Rezoning Transportation Analysis
Petition Number: Insert Zoning Petition #2022-032
General Location Identifier: 16720541

Revision Log:

Date	Description
07-26-22	First Review (PDM)

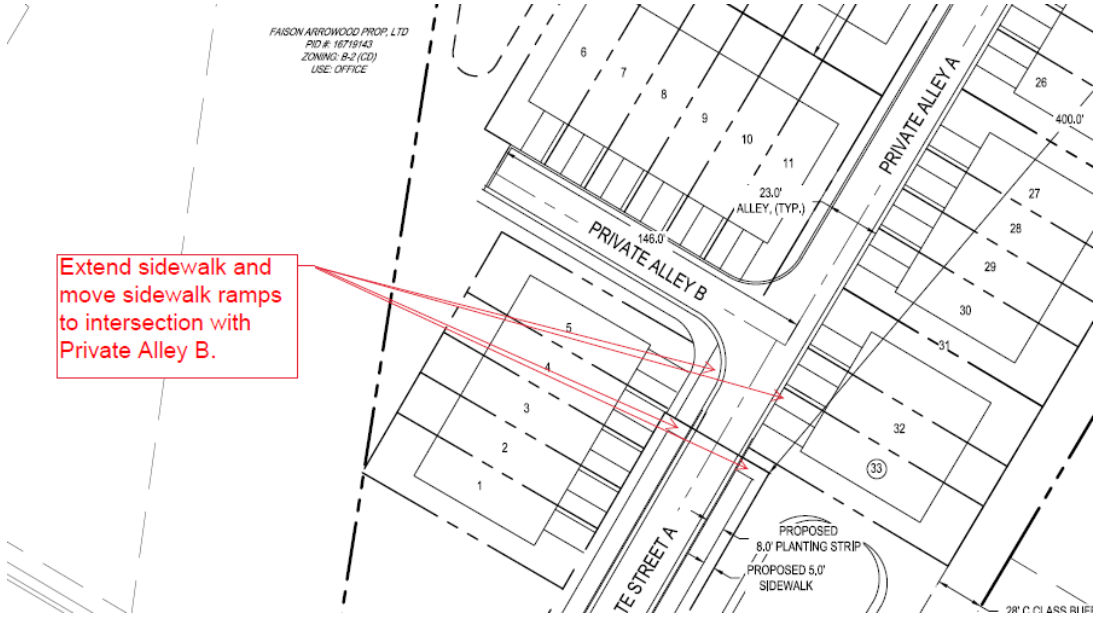
1. **Curblines:** The proposed zoning district has a setback measured from back of the existing or proposed future curblines.
 - a. **W Arrowood Road:** The future location of curb and gutter is in its existing location.

Label and dimension the curb and gutter from the centerline for each road on the site plan.
2. **Traffic Study:** A Traffic Impact Study (TIS) is not necessary for the complete review of this petition due to the site generating less than 2,500 daily trips. If during the permitting process the site generates more than 2,500 daily trips, then a traffic study will be required.

3. Site plan and conditional note(s) revisions are needed to commit to installing a 12' multi-use path along Arrowood Road to meet the City Charlotte BIKES Policy.

4. Revise site plan to dedicate 50-feet of right-of-way from the Arrowood Road centerline if it does not exist. The site plan shall label and dimension the right-of-way from the road centerline. Ensure a continuous 50ft ROW is provide at a minimum for the full length of the site.

5. Add conditional note stating, "Intersection sight distance will be met per CDOT's Sight Distance Policy, dated May 2003, at the intersection of Arrowood Road and the proposed private street." Proposed private street off Arrowood Road may be subject to relocation if intersection sight distance cannot be achieved.

6. Site plan and conditional note(s) revisions are needed commit to installing a required Left-Turn Lane into the site on Arrowood Road into the site. label and dimension left-turn lane on site plan and add conditional note describing all turn lane design requirements. The existing left turn lane should be restriped to accommodate the new street.

7. Site plan and conditional note(s) revisions are needed to commit to extending the proposed sidewalk and ADA compliant sidewalk ramps closer to the intersection of Private Alley B.
